From: Darko Hrle [dhrle@encompasses.net]
Sent: Thursday, June 29, 2006 12:07 PM
To: Joanna F. Valencia
Subject: RE: Vista View - 05577 - 50' buffer issue
Follow Up Flag: Follow up
Due By: Friday, August 04, 2006 8:30 AM
Flag Status: Red
Attachments: image001.jpg

From: Darko Hrle [mailto:dhrl@encompasses.net]
Sent: Monday, June 26, 2006 4:10 PM
To: Joanna F. Valencia
Subject: Vista View - 05577 - 50' buffer issue

Conditions of plat approval specifically state that there will be a 50' buffer measured from the ordinary high water mark of the creek that is to remain in its natural condition - no construction activities (Item 1a-Environmental Elements). Please refer to the attached sketch that I have sent to Joanna - it might help see what is going on. Also, attached is a copy of the Conditions of Approval that addresses this issue. HPA/JARPA does not address this issue since it is concerned more with any work within the creek itself or its immediate vicinity. I believe that this 50' buffer was mostly driven by the DOE - it was requested by the County. Thanks,

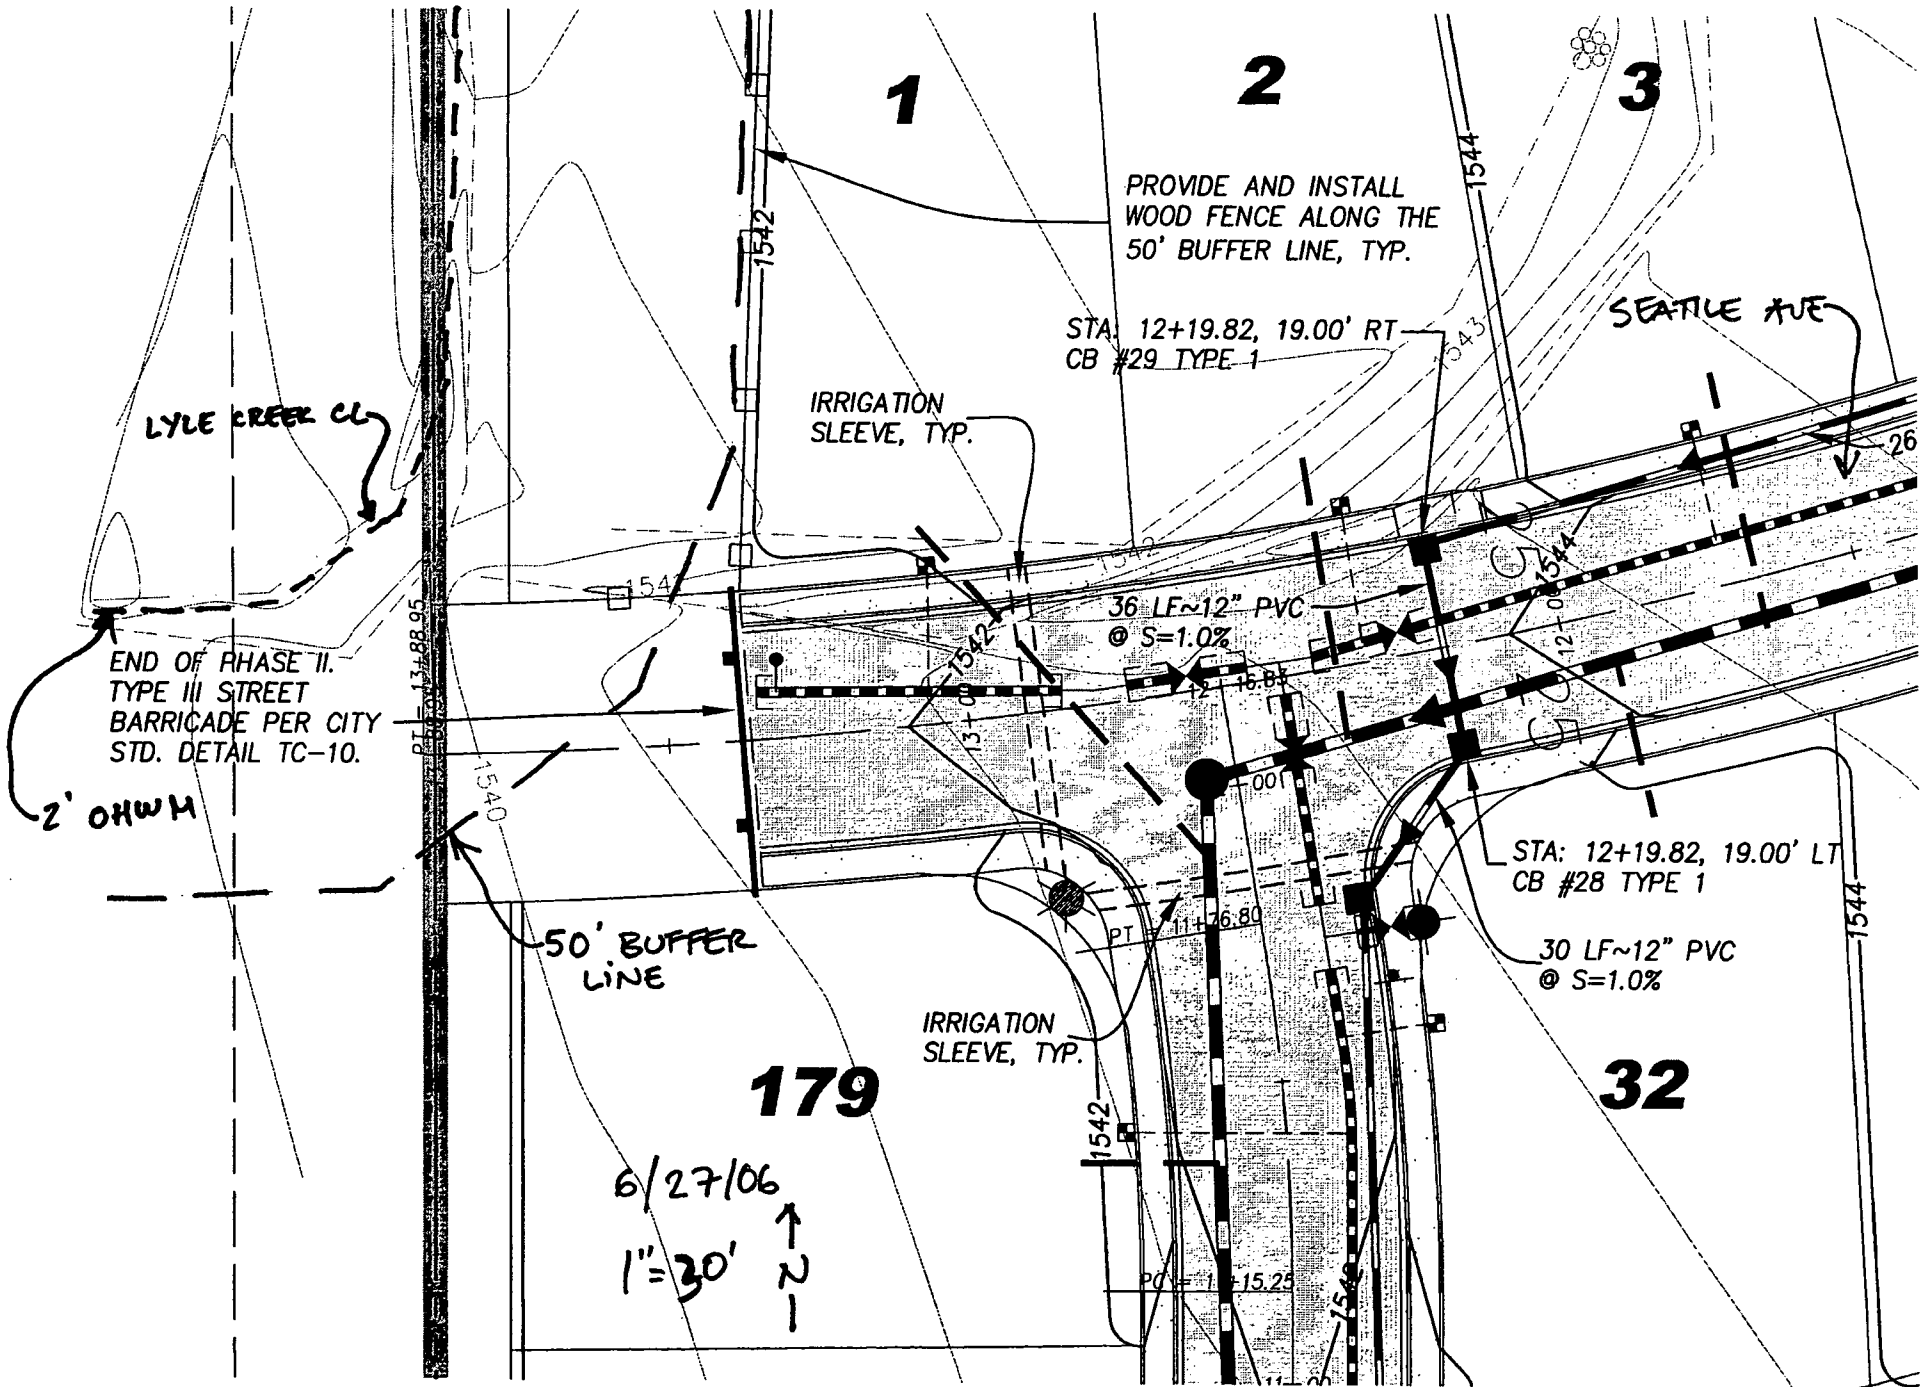
Please see attached. I spoke to my director about it, and as an option for now would it be possible to just develop the frontage to Lot 179 (per the hatched area on the drawing) to keep out of the buffer. I know this is Phase II of the project and we're unsure on when Seattle Ave will be at the point to be stubbed out, but this may be an option in regards to developing that lot. At the time of Seattle Ave need to go through, we would need to tackle that issue with WDFW-HPA Process. Let me know what you think.

I guess the simple solution to this would be – can we extend Seattle Avenue 50' to the west (to the property line as addressed by Peggy in her letter to you) even though the road will be within the 50' non-buildable buffer? We would need the direction from the County since the County was the lead for the SEPA review.

This issue goes back to the second review done by the City (before Peggy came on-board with the project). At that time, the City requested that we stay clear of 50' buffer with Seattle Ave. to avoid any possible environmental impacts/agency issues. If we have your approval to extend the road to the property line we can easily do it, and I can go back to the City and discuss it with them. Please let me know. Thanks,

Darko lets step back. 1. Where does it say (or who said) this is a buffer area and MDJ can not build the road. 2. What are the actual boundries. If they are the from what you show as a wood fence (50' from the shown fence) why do the plans show the road right up to the end of lot 1 and where does the house on lot 1 go ? Does it have to be back 50' from the fence? 3. Is there a HPA/JARP in process and what does it address? Where I am going with this is we want a full width road and are not sure why we are not getting one.

Thanks for the quick turn-around. I think that building road this way would be very inconvenient for the Contractor. What do you think about the option of building only curb, gutter and sidewalk along Lot #179 to within 5' of the property line and adding AC pavement section later when the HPA/JARPA process are completed? Thanks,
